HISTORIC AND DESIGN REVIEW COMMISSION

May 02, 2018

HDRC CASE NO: 2018-196
ADDRESS: 121 BUFORD
LEGAL DESCRIPTION: NCB 1369 BLK 6 LOT S 81.3 FT OF 5
ZONING: R-4, H
CITY COUNCIL DIST.: 2
DISTRICT: Dignowity Hill Historic District
APPLICANT: Chris Williams
OWNER: Chris Williams
TYPE OF WORK: Landscaping elements, hardscaping, installation of planters, landscaping walls, fencing
APPLICATION RECEIVED: April 18, 2018
60-DAY REVIEW: June 17, 2018

Exhibit 2: Original design with notes addressing non-compliant findings:

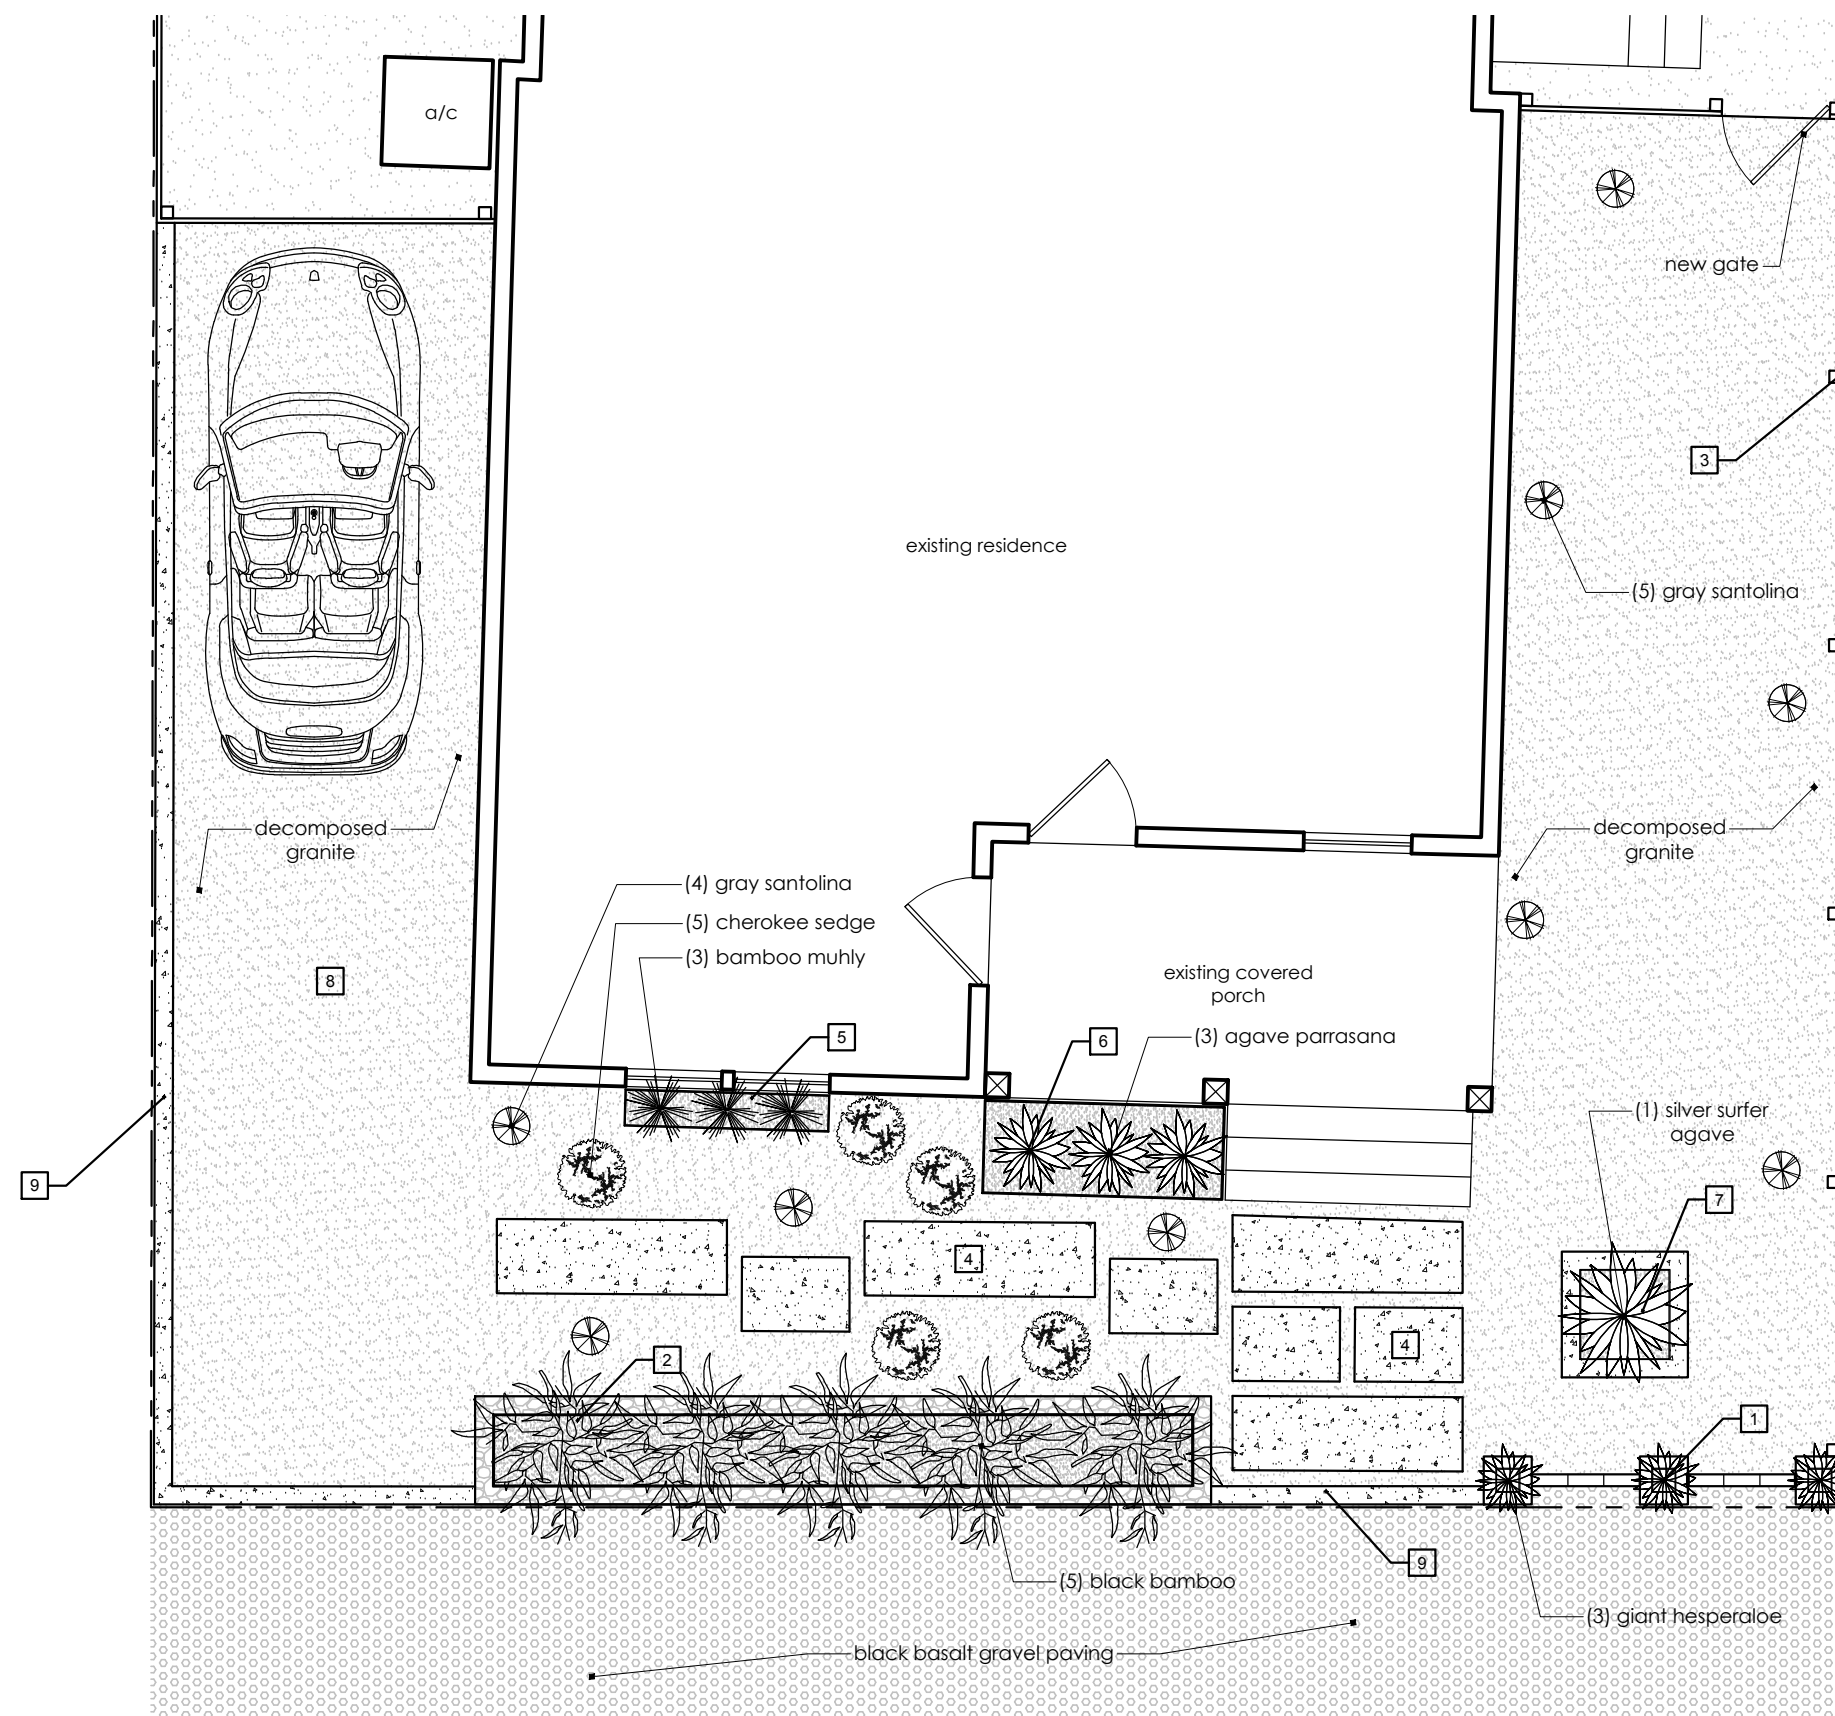
#5 and #6. Wood trim to be added to planters (window and porch)

#8. Gabion wall will be replaced with wood planter of same dimensions

#2. City called to install sidewalk

#7. Low ground concrete planter from original plan was not installed (not pictured)

#3. More plants to be added to side yard

#1. Side fence reduce to 4 ft

#4. Pavers to be replaced with crushed granite walkway

#9. Solar screen to be removed and replaced with wood planter of same height and depth of #8
